October 21, 2019

RE: Westhill Rezoning
Balzer Job #24190010.00

The following letter hereby addresses the comments provided to our office on October 3, 2019 for the above project. Please find our responses to your comments below.

CONCEPTUAL MASTER PLAN

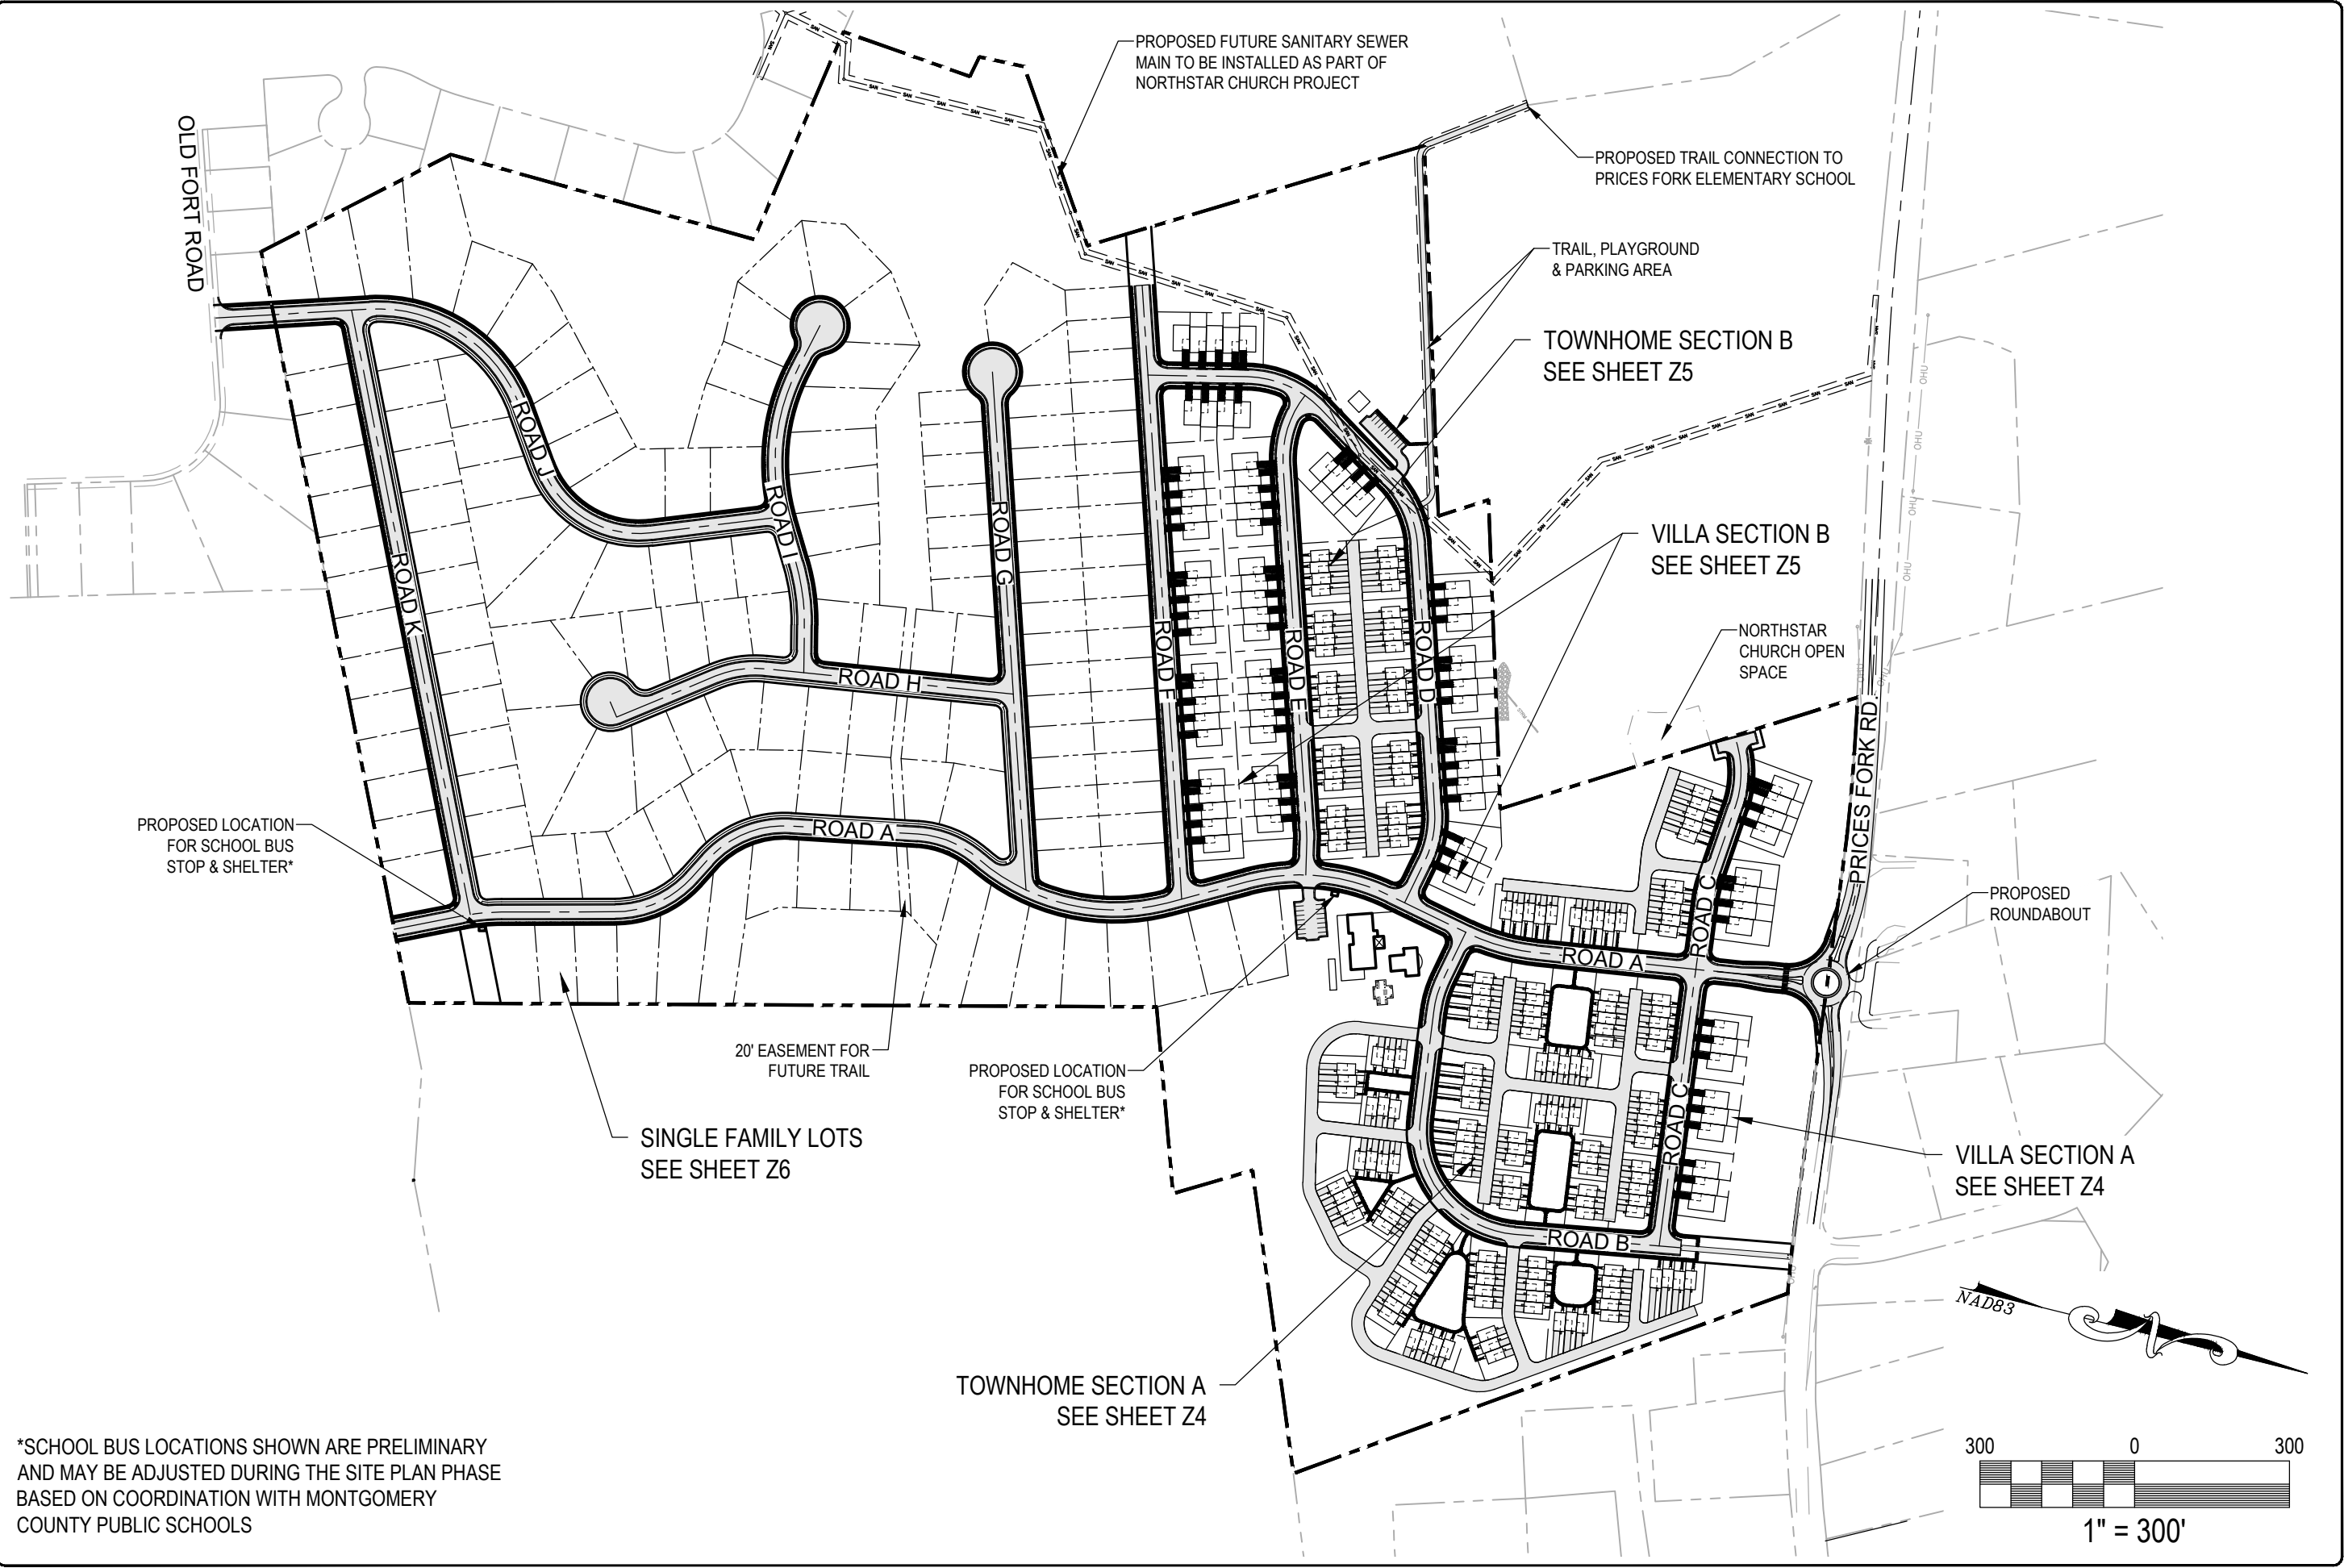
3. Accommodations for school buses, such as a shelter and adequate turning radius, should be considered.
 - **All turning radii proposed will meet requirements for large vehicles such as school buses and fire trucks. Two bus stop/shelter locations area shown on the masterplan.**

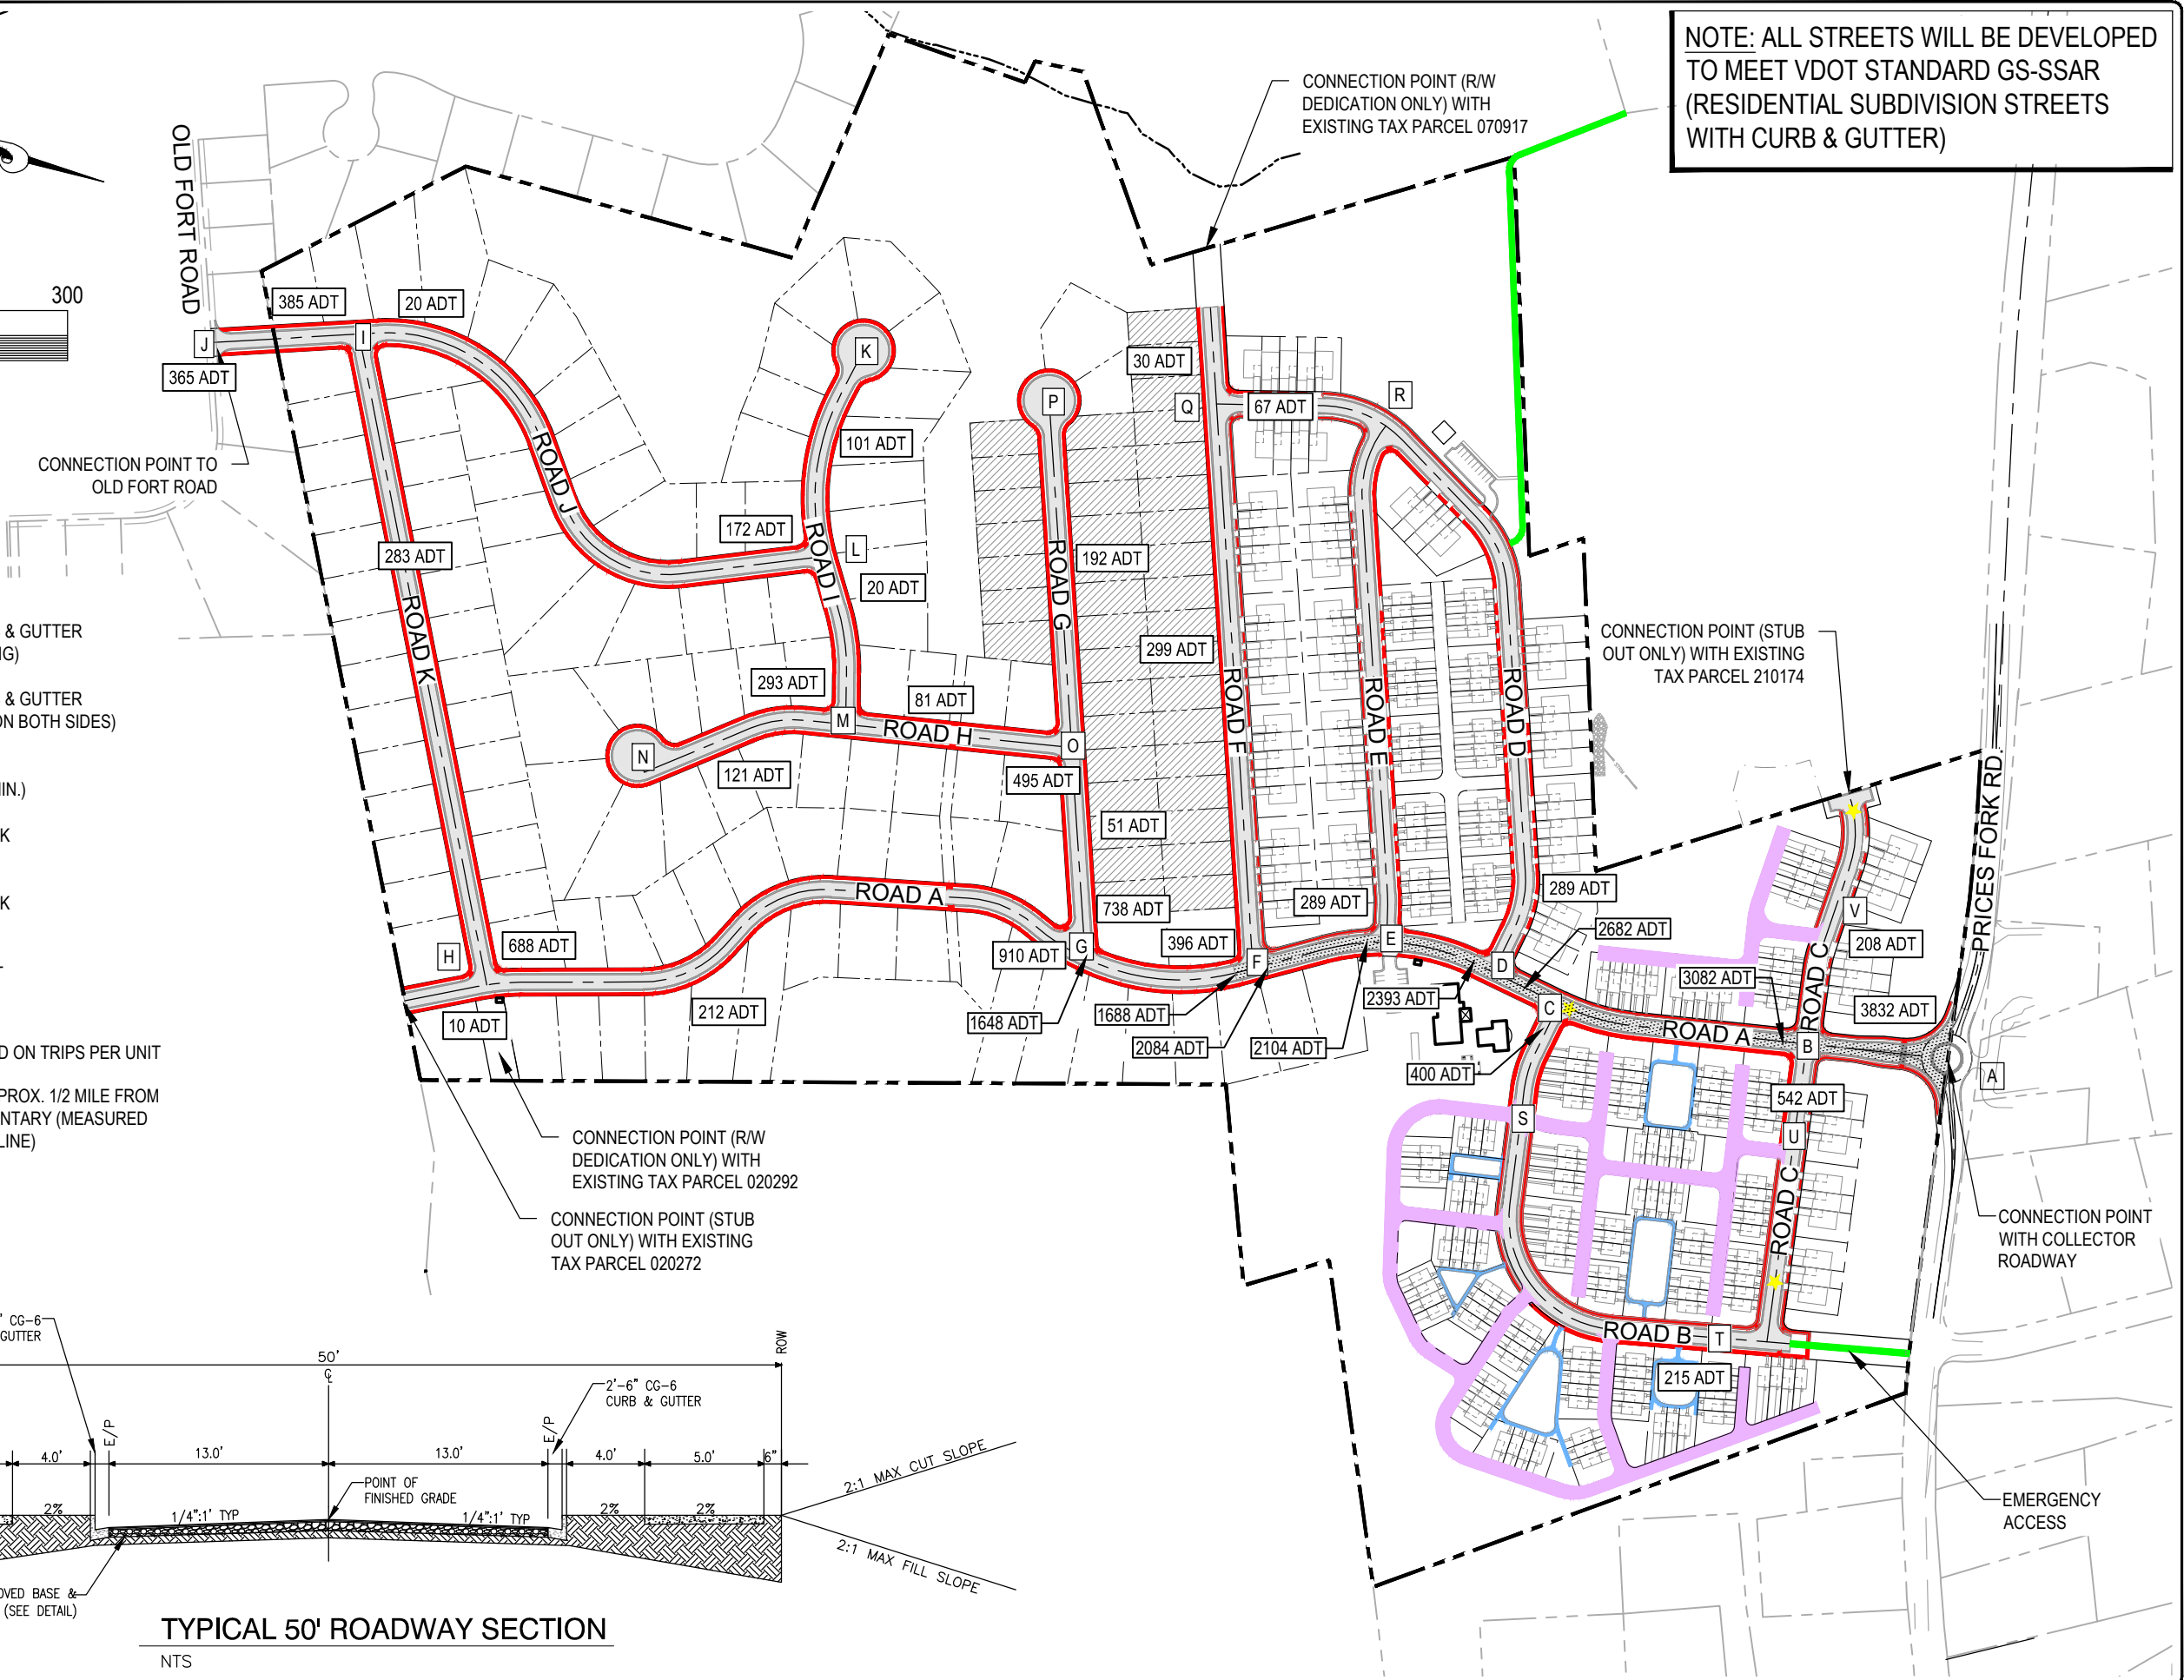
Transportation Exhibit (Figure Z8):

2. VDOT requires pedestrian accommodations related to school connectivity. Please identify the point(s) where the road centerline distance is one-half mile from Prices Fork Elementary (as measured along Prices Fork and into the subdivision.) Inclusion of sidewalk on both sides of the interior streets is already provided, however, please refer to Montgomery County Prices Fork Village Plan, specifically the ViTL plan for paved shoulder and sidewalk adjacent Prices Fork Road.

3. Please provide specific street cross-sections with defined widths (not variable as shown), where (if) on-street parking will be allowed, and detail as to how storm runoff will be conveyed (curb/gutter or swale). Note the following items:

- a. Within the "Site Development Regulations" of the narrative it is described that "road widths will be designed to allow for on-street parking on one or both sides of the road." However, the legend on Figure Z8 describes public roads to be "no parking".
 - **This has been clarified in the application narrative as well as on Sheet Z8.**

- **The note has been added to the plan sheet Z8.**

- **These distances have been shown on the plan sheet. The proposed roundabout and road improvements take into account for the future trail along Prices Fork Road. A trail and easement is being secured across Virginia Tech to allow pedestrians to access Prices Fork Elementary School.**

- **This standard detail has been revised.**
4. On the legend, please identify the 10' Asphalt Multi-Use Trail as "Private".
- **These have been noted as Private in the Legend.**
